COMMENTS AND RESPONSES ON DRAFT EIR

Transit Center District Plan and Transit Tower

PLANNING DEPARTMENT
CASE NO. **2007.0558E** and **2008.0789E**

To: Members of the Planning Commission and Interested Parties
From: Bill Wycko, Environmental Review Officer
Re: **Attached Comments and Responses on Draft Environmental Impact Report
Case No. 2007.0558E: Transit Center District Plan and
Case No. 2008.0789 Transit Tower**

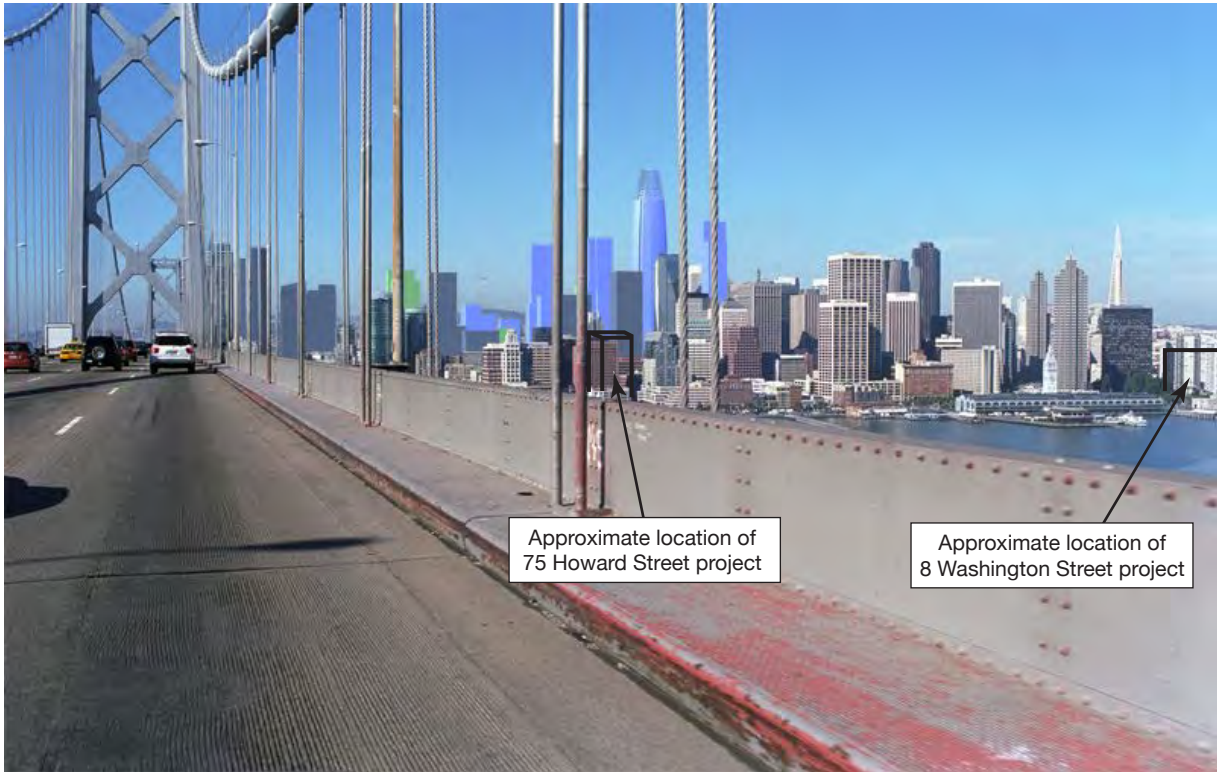
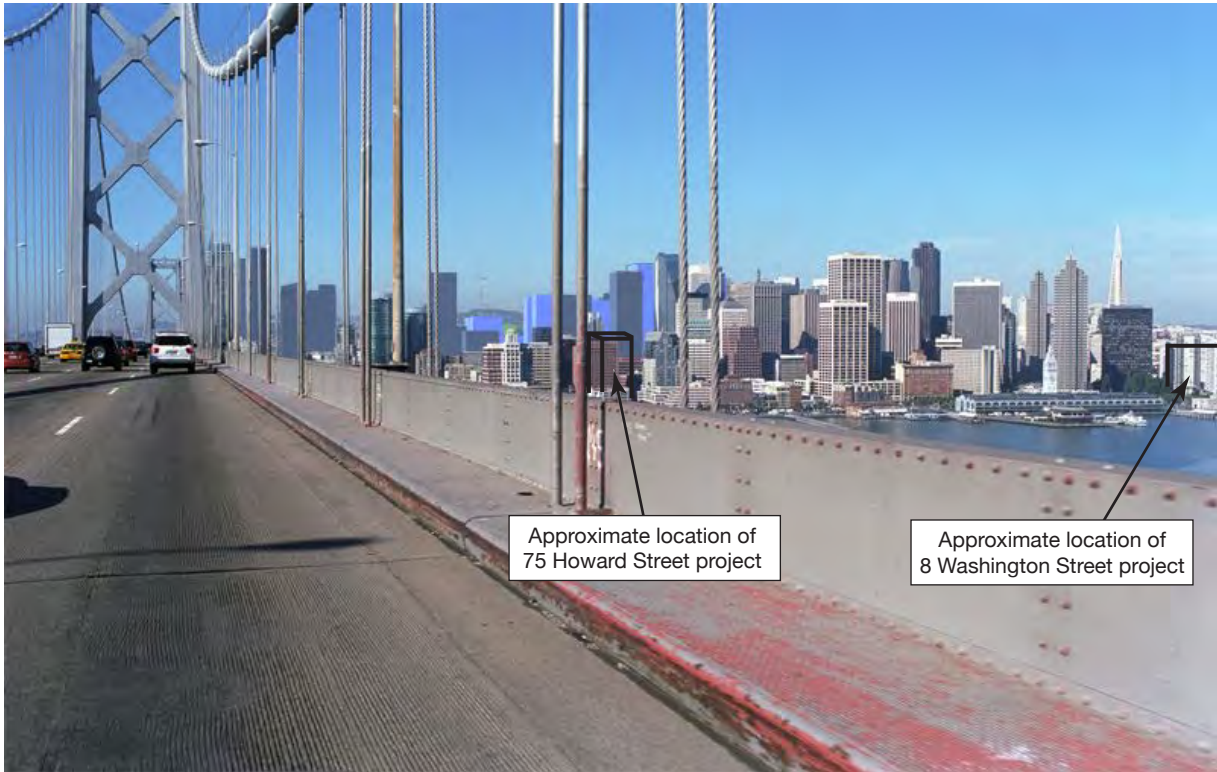
Comment AE-7: Is the proposed project at 8 Washington Street included in the cumulative scenario photomontage from Treasure Island?

“Does cumulative development one from T.I. include the proposed 8 Washington project?” (*Sue Hestor, on behalf of SFRG*)

The project at 8 Washington Street (Case No. 2007.0030E, Final EIR certified and project approved by the Planning Commission on March 22, 2012) is not shown in the visual simulation from Treasure Island (EIR Figure 39B, p. 150), which depicts potential development in the Plan area and nearby cumulative towers. The 8 Washington Street project, which would be up to 136 feet in height, is proposed for a location approximately 2,200 feet (0.4 miles) northeast of the proposed Transit Tower site, and equally distant, or farther, from any location in the Plan area proposed for an increased height limit. Because Treasure Island is northeast of the Plan area (its southernmost location is at approximately the same latitude as the Municipal Pier at Aquatic Park), the view in Figure 39B is looking southwest. In this view, the 8 Washington Street project would be nearly indistinguishable against the immediate backdrop of the four 22- to 25-story residential buildings of Golden Gateway Center and the 27-story, 398-foot-tall office building at One Maritime Plaza (the former Alcoa Building). Even from the Bay Bridge, closer to San Francisco, as shown in EIR Figure 40B, p. 152, the proposed 8 Washington Street project would not result in a substantial adverse change in views. **Figure C&R-3** illustrates the approximate location and size of the approved 8 Washington Street project from this viewpoint, using a “wire-frame” model to demonstrate the generalized massing of this project. Therefore, the 8 Washington Street project would not combine with potential future development in the Plan area to result in a significant cumulative impact in views from Treasure Island.

Also not depicted in the cumulative visual simulation from Treasure Island (EIR Figure 39B) is a recently proposed project at 75 Howard Street, discussed in the response to Comment PD-1, p. C&R-18. As noted in that response, no application was on file for this building at the time the Draft EIR was published. This building would be approximately the same height as the Rincon Center towers across Howard Street, but would be taller than buildings west of it. However, in the cumulative scenario, as with 8 Washington Street, this building would largely blend in against proposed or anticipated buildings behind it in the view from Treasure Island. In the

● Figure 64 (revised)
 Maximum Extent of New Shadow on Portsmouth Square

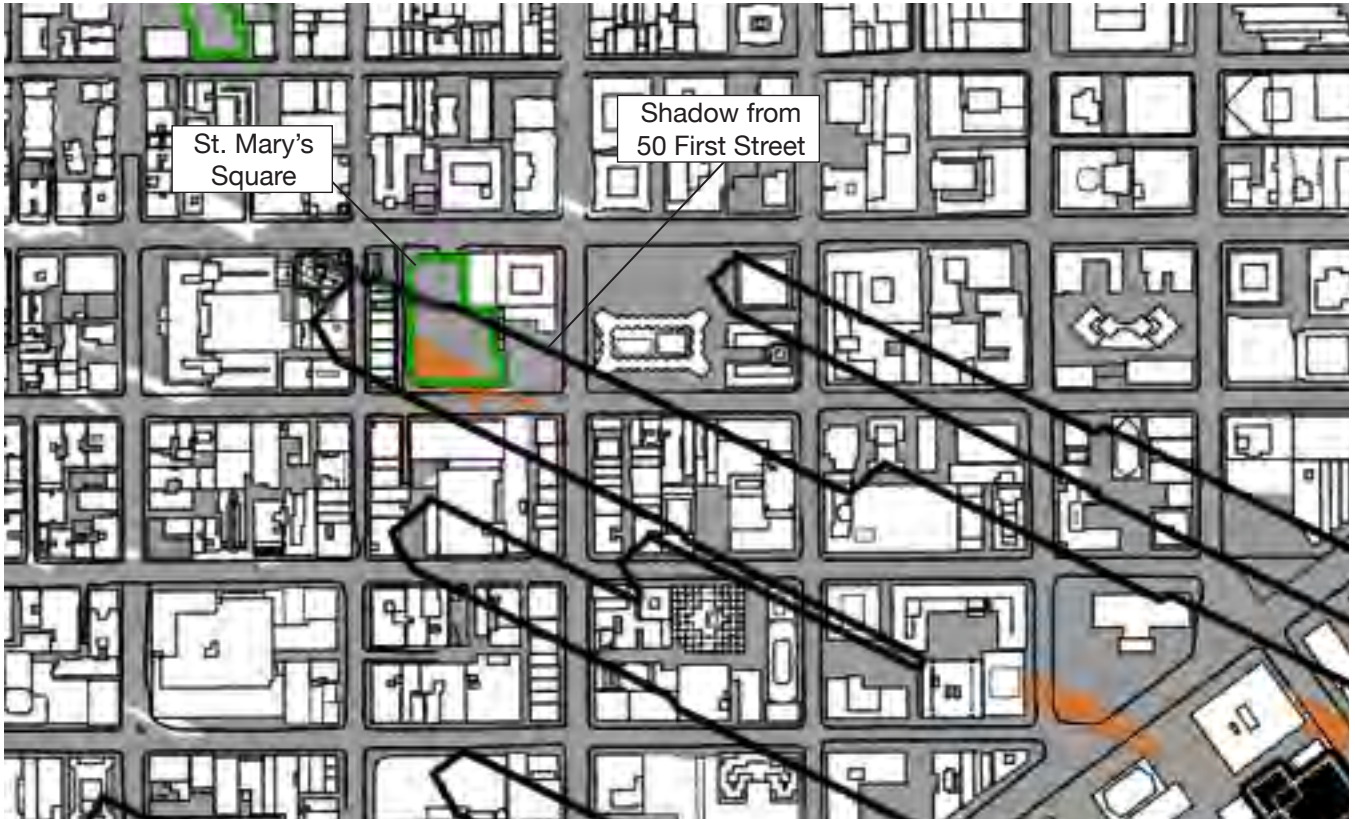
"As p. 524 of the DEIR states, 'The greatest one-time effect would be on Portsmouth Square. The Transit Tower would add about 22,500 sq ft of shadow, covering about 35% of the park, at 9:15am in early November and late January.' Figure 64 (p.512) shows that the maximum extent of new shadow on Portsmouth Square will cover the portion of the upper level of Portsmouth Square that currently provides the greatest amount of open space. This specific area is the primary open-air 'plaza' of the park and is often used for tai chi, exercising, and the stage area for cultural events in this neighborhood.

It is noted that the DEIR included two graphics in the shadow analysis which incorrectly presented the same figure, of draft Plan impacts, twice and did not depict Transit Tower shadow. Accordingly, EIR Figures 64 and 65, pp. 512 and 514, have been revised to depict maximum shadow from the proposed Transit Tower alone on Portsmouth Square and St. Mary's Square, respectively. The revised figures are included in this Comments and Responses document at the end of Section E, Revisions to the Draft EIR, following p. C&R-139.

On pages 512 and 514, Figures 64 and 65 are revised to depict maximum shadow from the proposed Transit Tower alone on Portsmouth Square and St. Mary’s Square, respectively. (The revised figures appear following p. C&R-139.)
